Amendments to the Drawings:

REMARKS

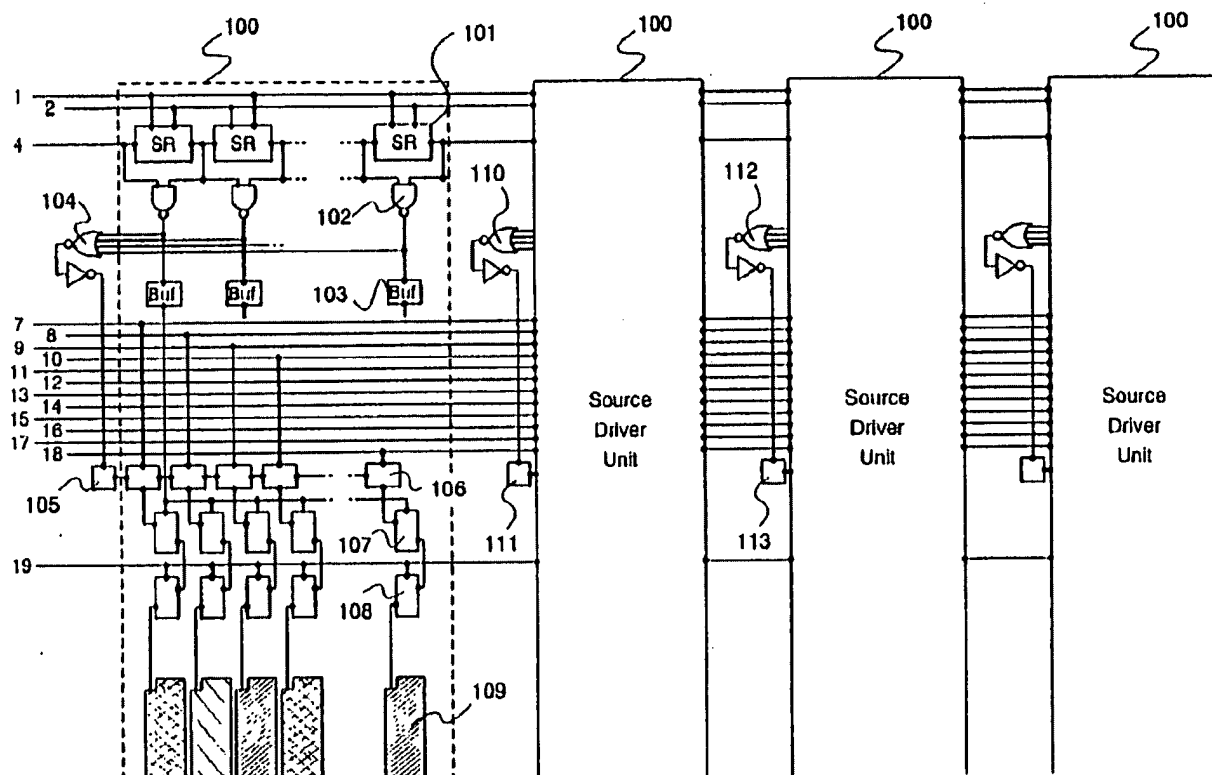
Paragraph 4 of the Official Action objects to the drawings asserting that "the current source provided in the source signal line driving circuit for supplying a current to the level shifter" is not shown in the drawings (page 3, Id.; emphasis in original). The Applicants respectfully disagree and traverse the above assertion in the Official Action.

The prior art, either alone or in combination, does not teach or suggest all the features of the independent claims, as amended. For example, independent claim 1 has been amended to recite "a current source provided in said source signal line driving

circuit for supplying a current to said level shifter based on the pulse from the shift register" (see, e.g., Figure 1, reproduced below).

The Applicants respectfully submit that Figure 1, in fact, shows a whole driving circuit including a current source provided in a source signal line driver circuit, which is supported in the specification, for example, at page 16, line 14+. Reconsideration and withdrawal of the objections are requested.

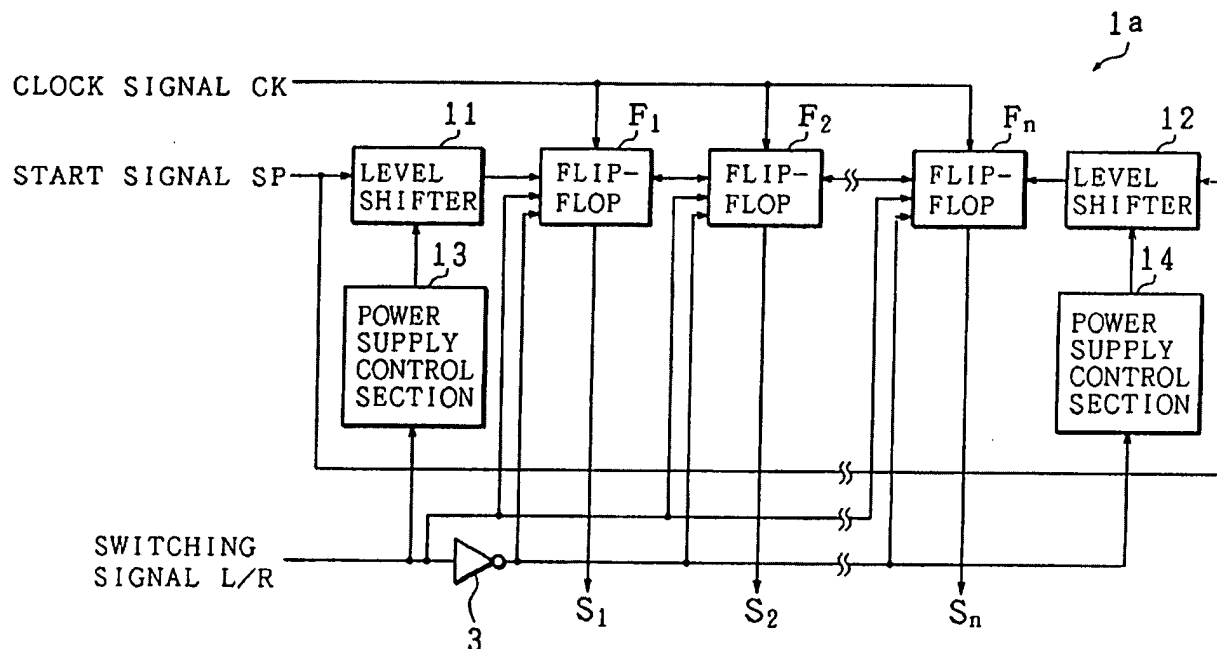
The Official Action relies on power supply control section 13 to allegedly teach the current source of the present claims, on electric power shifters 11 and 12 to allegedly teach the level shifter of the present claims, and on shift register 53a to allegedly teach the shift register of the present claims (page 5, Paper No. 20051011). It is noted that the shift register 53a (Figure 2) appears to include the flip-flops $F_1 \dots F_n$, the power supply control section 13, and the electric power shifters 11 and 12 shown in Figure 4. In any event, even if one were to assume that the power supply control section 13 is the current source of the present claims, Satoh does not teach or suggest that the power supply control section 13 supplies a current to the electric power shifters 11 and 12 (allegedly the level shifter) based on the shift register (allegedly shift register

53a and/or flip-flops $F_1...F_n$) (see Satoh at column 7, lines 12-14 and Figure 4, reproduced below).
